Section 75W Modification (MP 07_0106) Concept Plan Modification

Clemton Park Village

Concept Plan Modification

Submitted to Department of Planning and Infrastructure
On Behalf of Australand Holdings Pty Ltd

Figure 2 – Revised Street Naming Strategy for Proposed Lot 41 as approved by Canterbury City Council

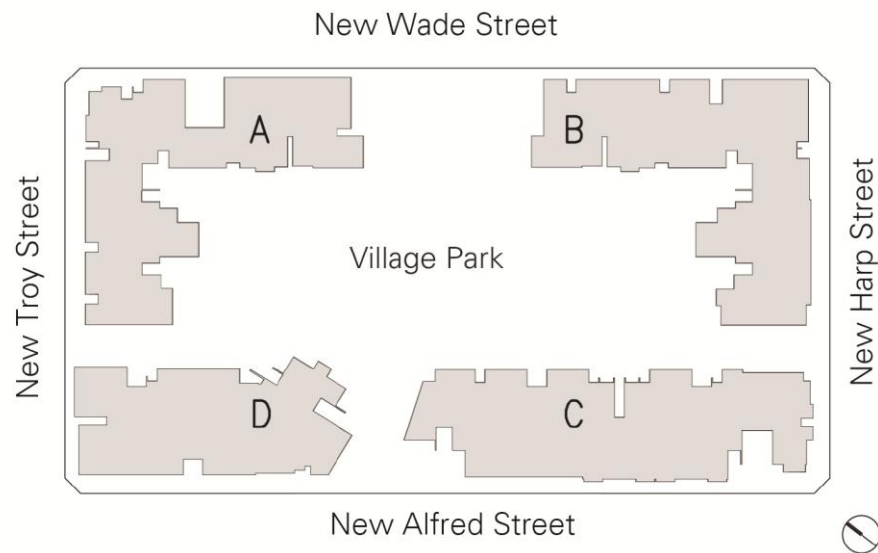
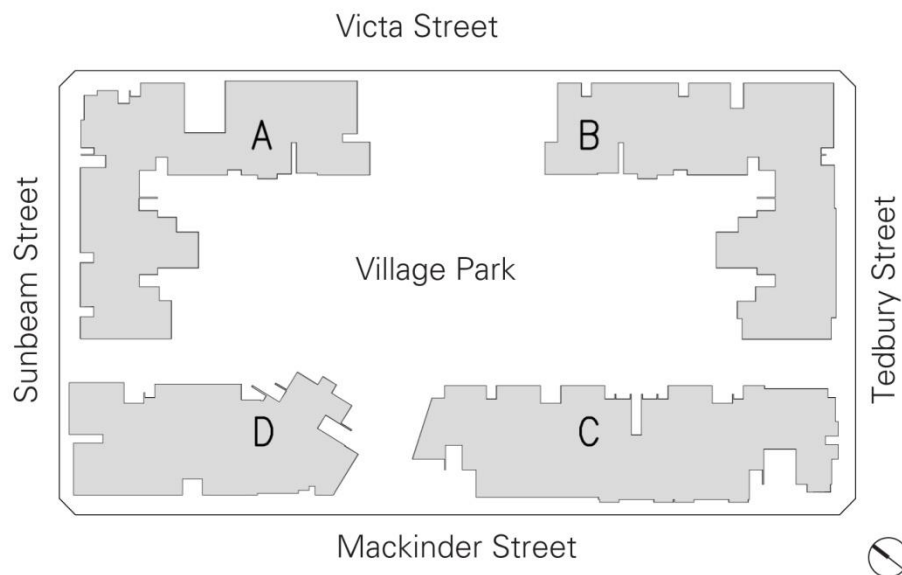
It should also be noted that since approval of the Concept Plan, Canterbury City Council has approved a street naming strategy for the entire Clemton Park Village site. Accordingly, the street names referenced in the Concept Plan Instrument of Approval and Final Statement of Commitments has been superseded. **Figures 1 and 2** show the originally approved and current street names bounding the

Proposed Lot 41 site that is the subject of this report. The new street names for Proposed Lot 41 are now known as Sunbeam Street to the north (formerly known as New Troy Street), Victa Street (east) (formerly known as New Wade Street), Tedbury Street (south) (formerly known as New Harp Street) and Mackinder Street (west) (formerly known as New Alfred Street). As outlined in Section 2.1, Condition A6 is also proposed to be modified as it applies to Proposed Lot 41 to reference the Council approved street naming strategy.

It is also requested that the street names referenced in the condition be updated to reflect Australand's naming strategy for the entire Clemton Park Village site. It is proposed to modify Condition A6(2)(a)(i) and Condition A6(2)(b) to replace 'New Alfred Street' with 'Mackinder Street'. A separate section 75W Modification will be submitted by Australand to revise the street names references in Condition A6 as they apply to Lot 42 in due course.

Figure 3 – Proposed location of additional height

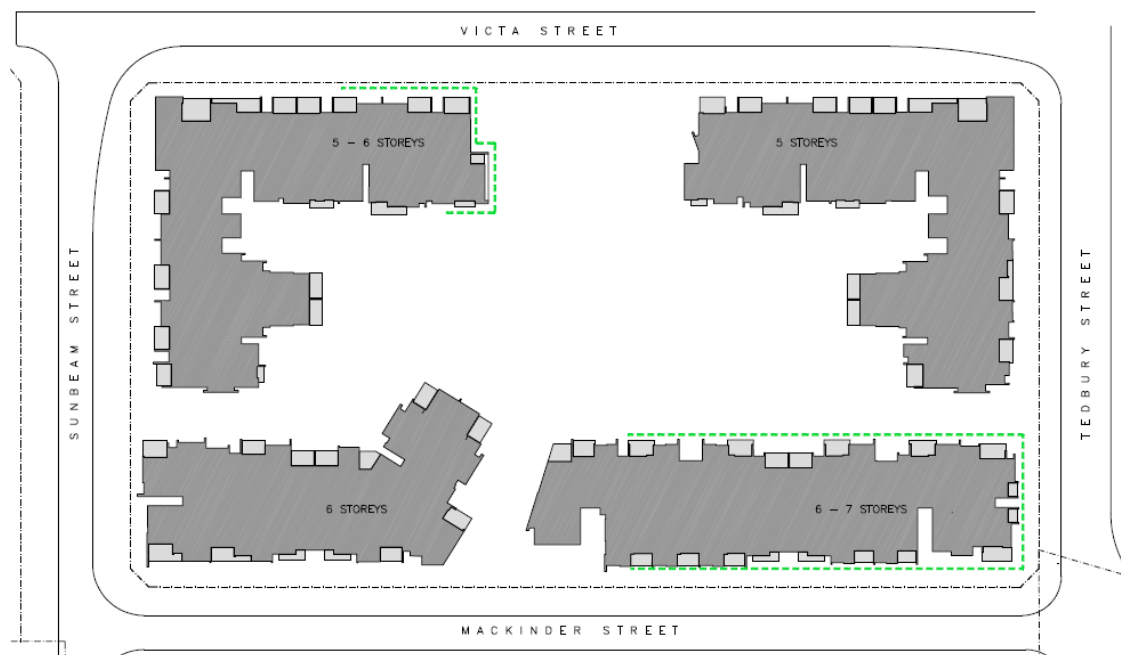
Reason for Modification: The approved Concept Plan restricts height by imposing a maximum six (6) storeys for future development on Proposed Lot 41. This section 75W modification proposes to amend Condition A4 to increase the maximum permissible height on Proposed Lot 41 by one additional storey. The increase in height is sought to provide flexibility for future building designs, whilst responding to the site's constraints, and also ensuring the other terms of the Concept Plan approval can be satisfied.

Proposed Lot 41 experiences a cross site fall of approximately 3.20m along Victa Street (formerly known as New Wade Street) and 2.55m along Mackinder Street (formerly known as New Alfred Street) from north to south, respectively. Proposed Lot 41's topography and the capacity of the surrounding street network limits the location of vehicular entries and exits to the future basement car park. In addition, the Concept Plan approval requires the provision of a public park to face Victa Street (currently referred to as New Wade Street in Concept Plan Condition A6) which is "*clearly accessible and corresponds (in grade) to the surrounding public domain*" (refer to Future Environmental Assessment Requirement No. 13 of the approved Concept Plan).

These factors result in sections of the basement protruding out of the ground level along Victa Street (formerly known as New Wade Street), Mackinder Street (formerly known as New Harp Street) and Tedbury Street (formerly known as New

Alfred Street). However, through the design process of the Stage 4 DA, Kann Finch Architects have identified the opportunity to provide some two-storey apartments with sunken courtyards addressing the street frontages to screen part of the protruding basement car park structure fronting the street. Residential flat buildings can then be constructed around, and on top of, the two storey apartments. The design outcome results in a maximum six (6) storey development fronting a minor stretch of Victa Street at the lowest part of the site, comprising four two-storey apartments directly accessible from Victa Street and four storeys of residential flat building. Along Mackinder Street and Tedbury Street, the same design response achieves a maximum of seven (7) storeys, comprising six two-storey apartments accessible from both street frontages beneath five (5) storeys of residential flat building. The areas of the site that will be effected by the additional storey are shown in **Figure 3** below. Australand's development application documentation has been provided at **Appendix C** for illustrative purposes to show the proposed design detail resulting from the increase in storeys. A typical section of the two-storey apartment and sunken courtyards proposed for Victa Street, Mackinder Street and Tedbury Street is also provided at **Figure 4** to illustrate the proposed design outcome.

The additional storey and sunken courtyards of the apartments diminish along both Victa Street and Mackinder Street as the site levels change. Accordingly, there are only very limited extents of the building facade that result in a full additional storey at street level. At the higher portions of the affected areas, the additional storey presents as a half storey (or less) rather than the full 6/7 storeys described above. The additional storey for a minor extent of the affected street frontages provides sufficient flexibility from the prescriptive height controls, whilst still enabling Australand to maintain the approved number of storeys for the remainder of Proposed Lot 41, consistent with the Concept Plan approval. Despite the increase in building height, the total approved gross floor area will remain unchanged and accordingly there is no proposed increase in building footprint that could impact upon the site's open space provisions. It should be noted that the Stage 4 DA provides the required 3,500m² of publicly accessible park.

Lot/Building	Land Use	Maximum Height Storeys / RL
Lot 42	Mixed Use	6 storeys (refer to A6 for height range)
Lot 41	Mixed Use/Open Space	6 7 storeys (refer to A6 for height range)
Lot 11	Residential/Child Care	4 storeys / RL 39.5 40.2AHD
Lot 21	Residential	3 storeys / RL 36.4 AHD
Lot 31 Building 5A	Seniors Living	4 storeys / RL 32.75 AHD
Lot 31 Building 5B	Seniors Living	6 storeys / RL 38.75 AHD

- i) a maximum of ~~6~~ 7 storeys for development fronting ~~New Alfred Street~~ **Mackinder Street (formerly referred to as New Alfred Street) and Tedbury Street (formerly referred to as New Harp Street);***
 - ii) a maximum of ~~5~~ 6 storeys for the remainder of the site.**
- b) A publicly accessible park is to be provided facing ~~New Wade Street~~ **Victoria Street (formerly referred to as New Wade Street)** with a minimum area of 3500m² and is to consist entirely of deep soil area.*

Figure 4 – Indicative floor plans and sections of two storey apartment arrangements fronting Victa Street, Tedbury Street and Mackinder Street

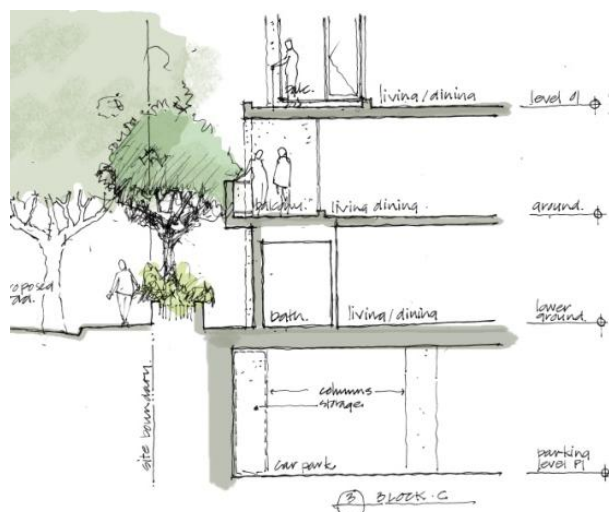
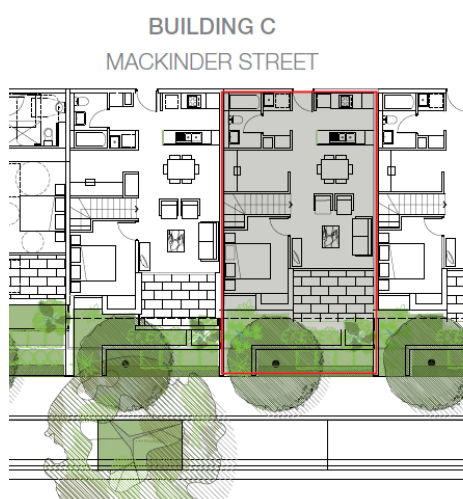
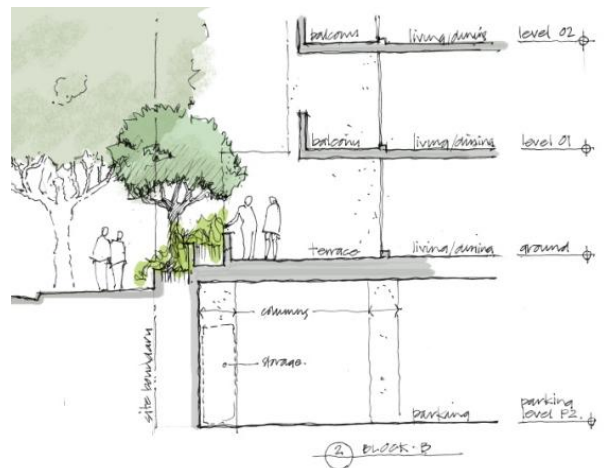
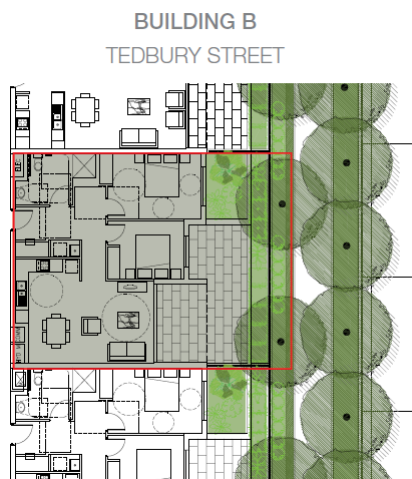
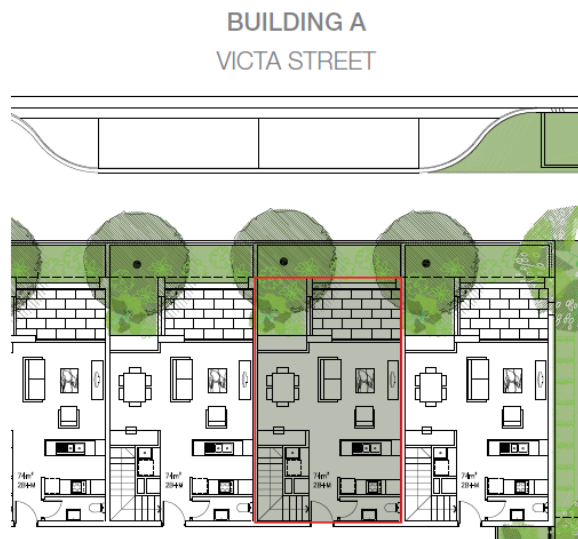
As outlined above, Australand's proposed design response to the site's topography and other constraints is to 'dress' sections of the basement structure protruding out of the ground with two storey apartments. The two storey apartments achieve an additional storey at the lowest portions of the site. Condition A4 of the Concept Plan approval indicates that storey is defined under the Residential Flat Design Code. For the purposes of this application any protrusion of basement car park structure beyond 1.2m of ground level is considered as a storey.
